## Executive Director's Recommendation

| <b>PROJECT</b><br><b>Proposed Site for the Gold Star Mothers National Monument</b><br>Washington, DC & Arlington, Virginia | <b>NCPC FILE NUMBER</b><br>7731                                      |

Site Selection Review

# Site B: Belvedere Near Theodore Roosevelt Bridge

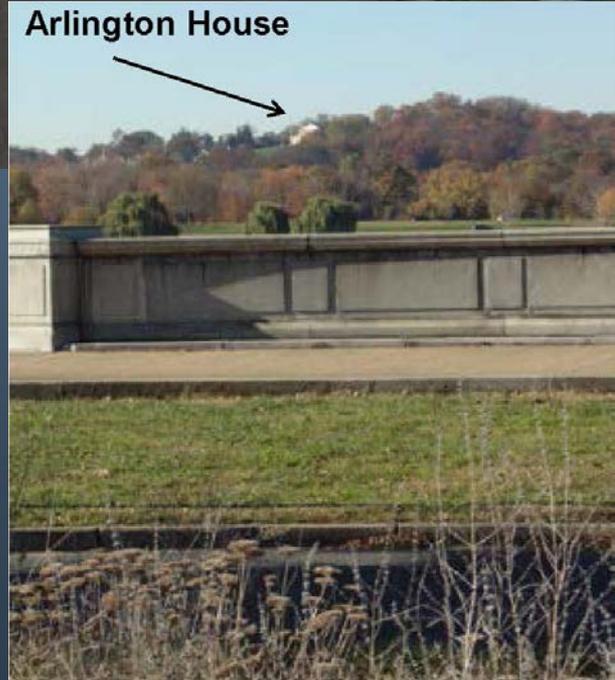
**Does not support** Site (B) due to its limited opportunity for contemplative space, inadequate accessibility and weak contextual connection to Arlington National Cemetery.

Of the three sites, this location holds the least opportunity for quiet and contemplation. The adjacent roadway and nearby active recreational uses do not lend themselves to peaceful reflection. Further, the site is not easily accessible for a variety of users and abilities. Although the lay-by could be utilized for vehicular drop-off and pick-up, this would directly intrude on the solemnity of the monument site. Street parking is located over 250 feet to the south of the site. Pedestrian access is provided along the Rock Creek Park trail, or through a complex network of paths that lead from the National Mall. Many of these require navigating the off-ramps and roadways connecting I-66, Rock Creek Parkway, Ohio Drive and Constitution Avenue. Foggy Bottom Metro Station is over a mile away.

The site provides some views of the Arlington National Cemetery grounds, located across the Potomac River. As such, the monument could have some relationship to the backdrop provided by the Cemetery, but its distance dilutes this connection. In addition, Rock Creek Park trail is heavily used by bicyclist and joggers, and may preclude the opportunity for a functional gathering space adjacent to the monument. The limited opportunity for contemplative space, inadequate accessibility and weak contextual connection to Arlington National Cemetery, make this a

challenging site for the proposed Gold Star Mothers monument. Therefore, staff does not support locating the monument at Site (B).

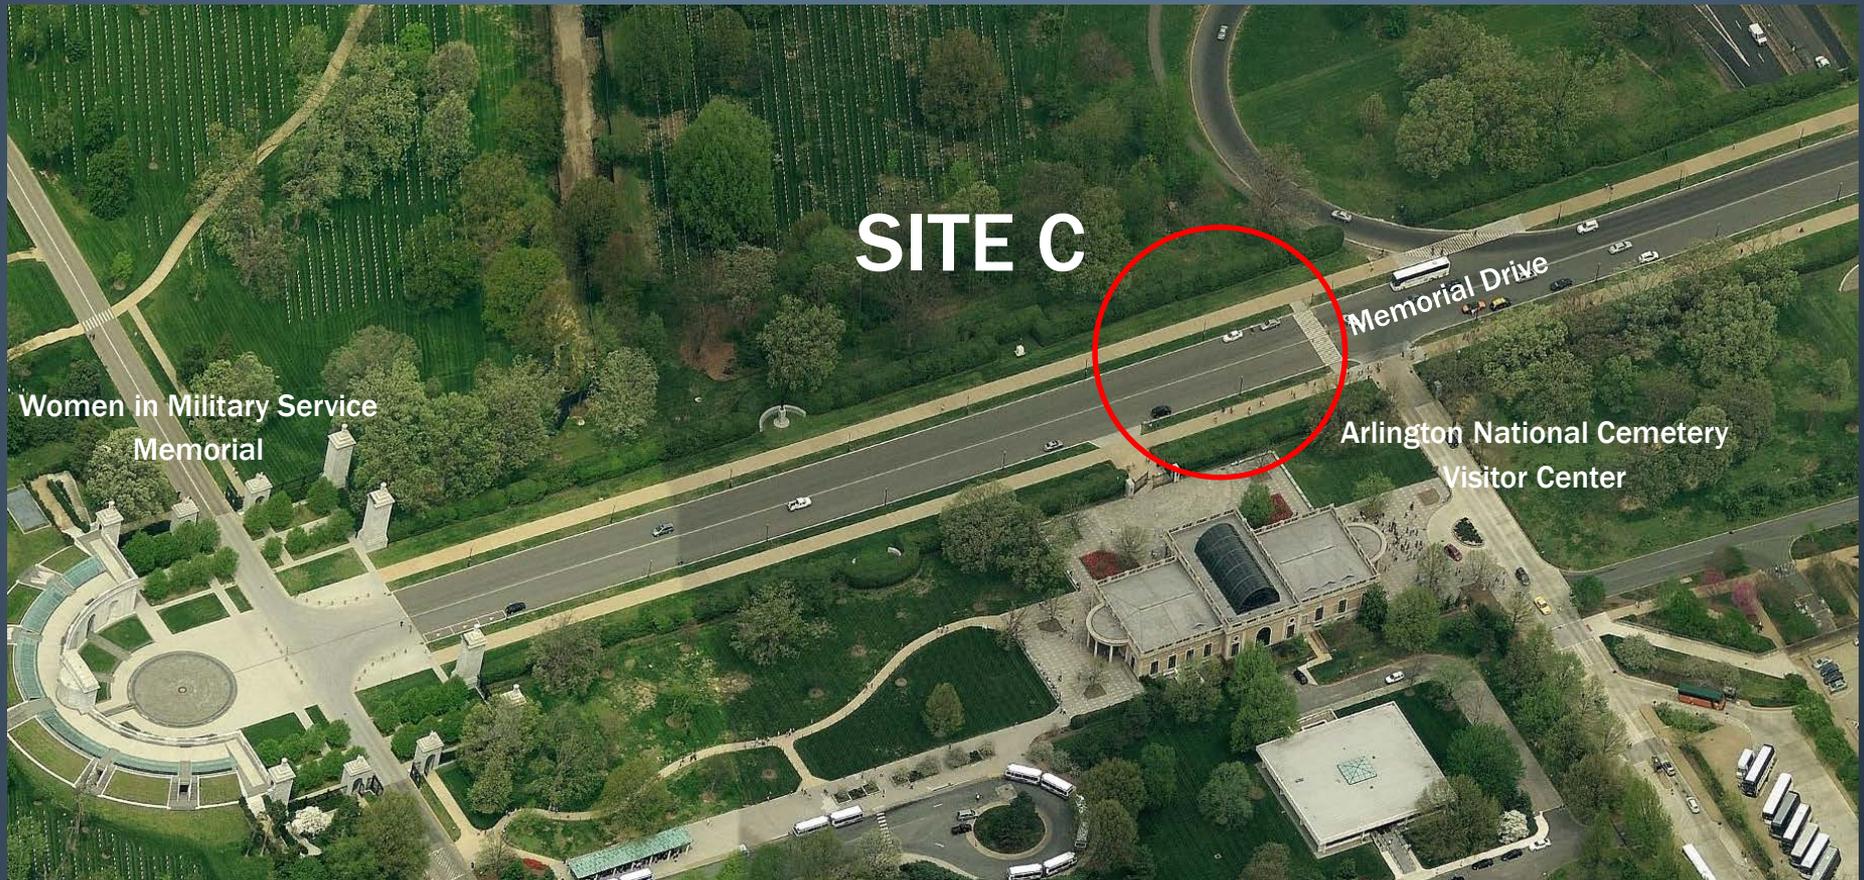
The niches along Memorial Avenue are typically 30 feet wide and 20 feet in depth. They are formed by creating a setback within the hedge line which defines the length of the avenue, with each niche located about 20 feet back from the sidewalk. The dominance of the Memorial Avenue axis and the recessed nature of the niches results in memorials which are viewed as a series of objects placed along the landscape of the corridor. No pedestrian connections are provided from each memorial to the sidewalk, and therefore, they must be viewed at a distance. Given this setting, staff believes it would be challenging to create a contemplative space in Site (C).

The site's location within the context of Arlington National Cemetery provides a thematic connection to the proposed monument. Staff notes, however, that many of the memorials within the existing niches are dedicated to military service groups, which is somewhat thematically different than families of those in the service. Further, the site is relatively accessible by a variety of means. However, the nature of the established niche design creates a series of challenges that appear incompatible with the site selection criteria. In particular, the niche's location along the highly-traveled Memorial Avenue may not permit the creation of a contemplative space, and the setback does not accommodate a gathering space for visitors to engage the monument. Therefore, the limited opportunity for contemplative space and lack of gathering space make Site (C) a challenging site for the proposed Gold Star Mothers monument.

# Site D: Adjacent to ANC Visitor Center

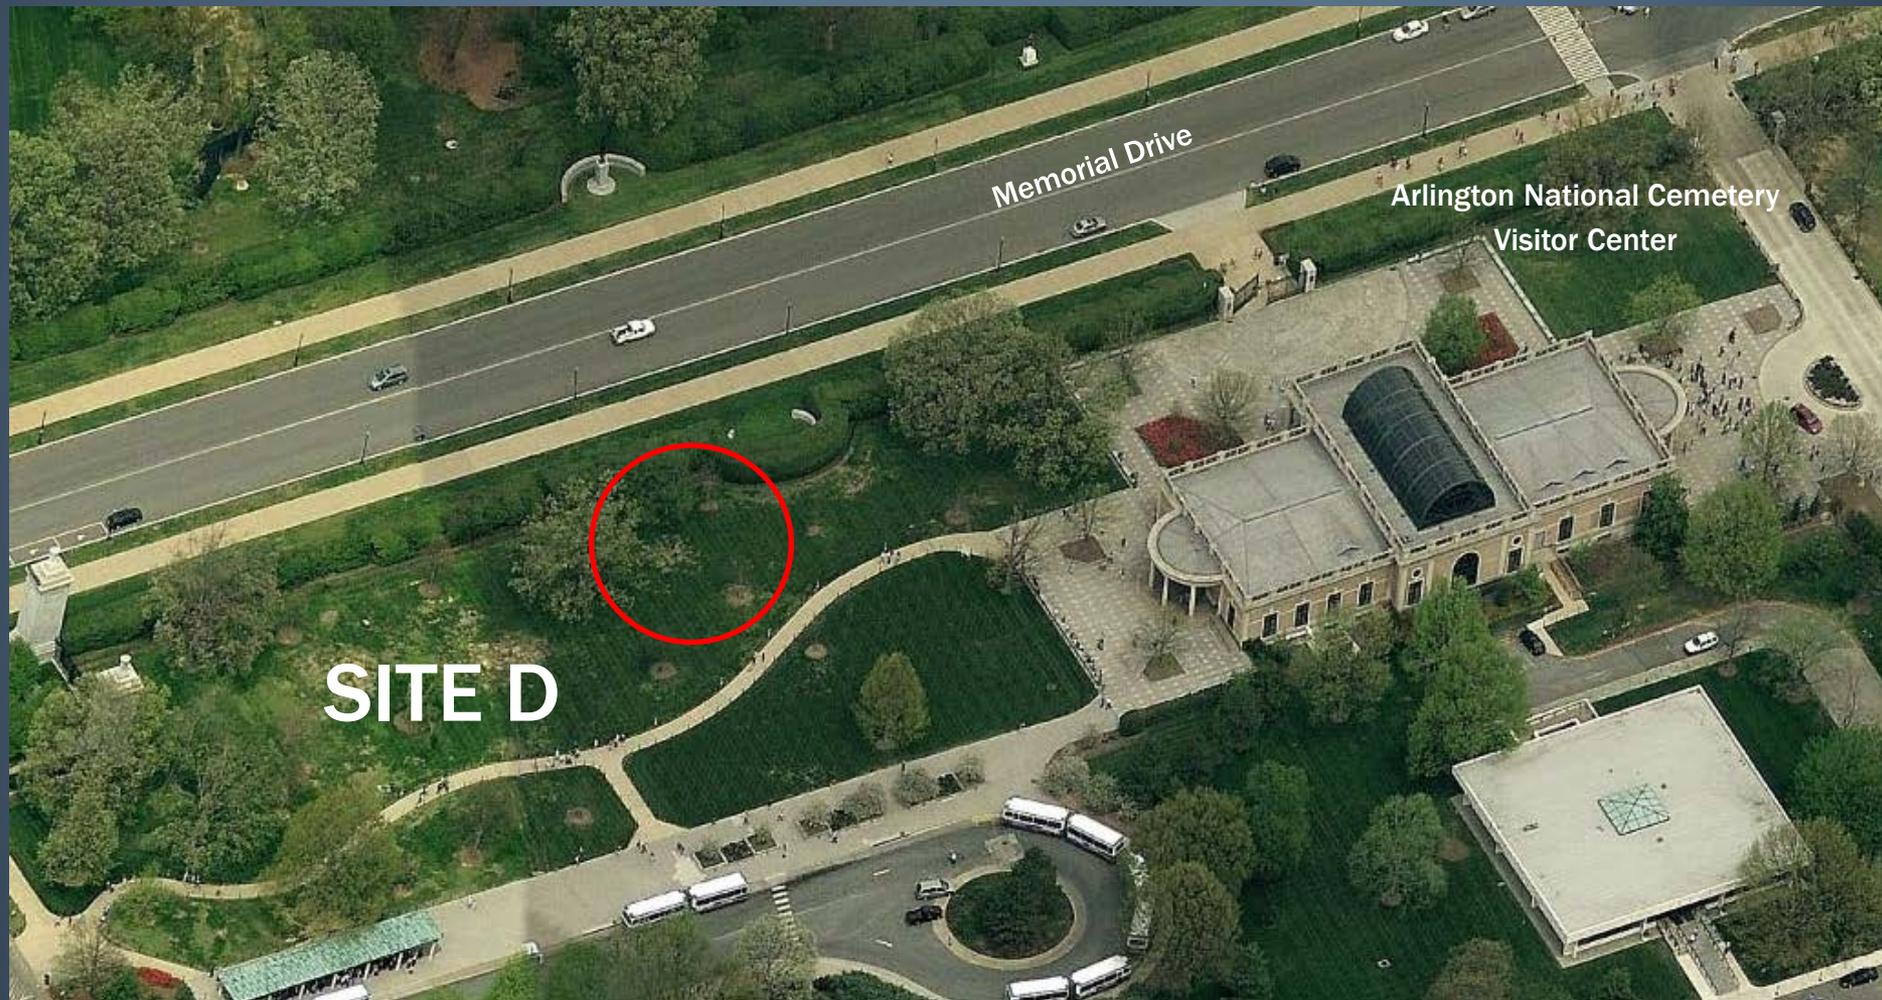
**Supports** selecting Site (D), the area adjacent to the Arlington National Cemetery Visitor Center, as the preferred location for the Gold Star Mothers Monument.

**Notes** that the size and location of Site (D) allows for a contemplative space; and further, the context of Arlington National Cemetery is a strong thematic connection to the proposed monument. Additionally, this location has potential for a visitor gathering space that will not impede existing circulation patterns or activities as noted with Sites (B) and (C).

**Recommends** that the sponsor develop a range of alternative design concepts for the monument within the area of Site (D), including variations in scale, material palette, placement and orientation. The next submission should reveal details about the physical relationship of the monument to the surrounding context and provide information about program needs at the site.

**Recommends** that NPS and the sponsor continue to coordinate with Arlington National Cemetery and the Department of the Army regarding Site (D), the location of existing utility lines and the design and placement of the proposed monument.

Of the three sites, this location holds the best opportunity for quiet contemplation. The size of the site and setbacks from adjacent uses could permit both a monument and a gathering space for visitors. Site (D) is located near the Arlington Cemetery Metro Station, and parking and bus service is provided at the adjacent Visitor Center. The site's location within the context of Arlington National Cemetery also provides a strong thematic connection to the proposed monument. Staff therefore finds that the proposed site is adequate for a modest sized memorial and encourages the NPS to continue to evaluate the site for the future Gold Star Mothers National Monument.

At a future date, NPS will submit the monument design for approval. Staff recommends that the sponsor develop a range of alternative designs for Site (D) that include further detail regarding exact placement within the site, the relationship of the monument to surrounding site features and monument orientation. Given the expected modest scale of the monument, it will be important to understand how the work will be placed within the larger landscape in Site (D).

Staff further notes that additional coordination with Arlington National Cemetery and the Department of the Army will be necessary regarding Site (D). The ANC Real Property Master Plan indicates potential utility lines bisecting the western portion of Site (D). These should be further evaluated as alternative designs are developed. In addition, the proposed designs should carefully consider the surrounding context of the ANC.
